DOCKETED	
Docket Number:	23-AFC-01
Project Title:	Morton Bay Geothermal Project (MBGP)
TN #:	258966
Document Title:	Exhibit J UAW Comments on Morton Bay Geothermal Project PSA
Description:	N/A
Filer:	Matthew Maclear
Organization:	Aqua Terra Aeris Law Group
Submitter Role:	Intervenor Representative
Submission Date:	9/4/2024 2:18:50 PM
Docketed Date:	9/4/2024

UAW Comments on Morton Bay Geothermal Project PSA

**Comments on the Deficient Air Quality Analysis in the California Energy Commission
Preliminary Staff Assessment for the Morton Bay Geothermal Project, June 2024
CEC-700-2024-003-PSA, DOCKET NUMBER 23-AFC-01**

⁶ PSA Figure 1-1.

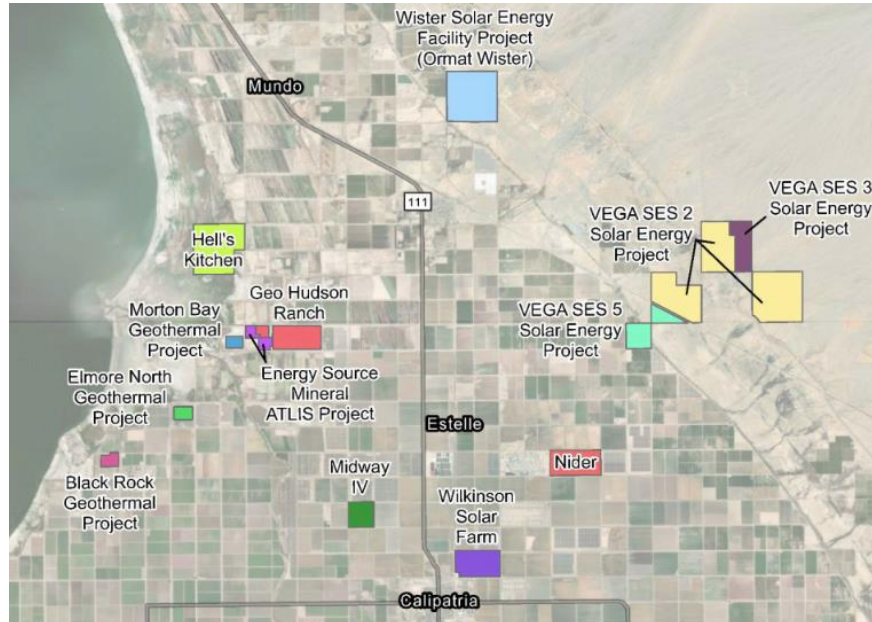
The Figure⁶ below shows the geographical area of the MBGP as well as other nearby projects. In particular, the Elmore North Geothermal Project and the Black Rock Geothermal Projects are believed to be “sister” projects under common ownership as the MBGP.⁷

C.1.3 Changes to the Salton Sea. It is clear from the previously shown Figure that the MBGP and its sister projects are located adjacent to the Salton Sea. Due to climate impacts in the Southwest United States, the Salton see is drying-out and shrinking. As this occurs, the smaller future footprint of the Salton Sea has and will continue to expose substantial new dry playas and these would be sources of increased fugitive dust based on wind entrainment. Substantial additional and massive PM (including PM_{2.5} and PM₁₀ or varying compositions, including toxic metals) will be emitted into the general vicinity of the Sea. It is well known that dry playas exposed due to shrinking bodies of water such as the Salton Sea can be very large sources of emissions. In fact, this has been noted specifically for the Salton Sea itself. Researchers at UC Davis note,¹⁷ in particular that newly exposed playas are “more susceptible to wind erosion” and “particularly emissive in terms of dust.” UC Riverside researchers have confirmed this as well, calling the consequences of this drying lake “an environmental catastrophe.”¹⁸
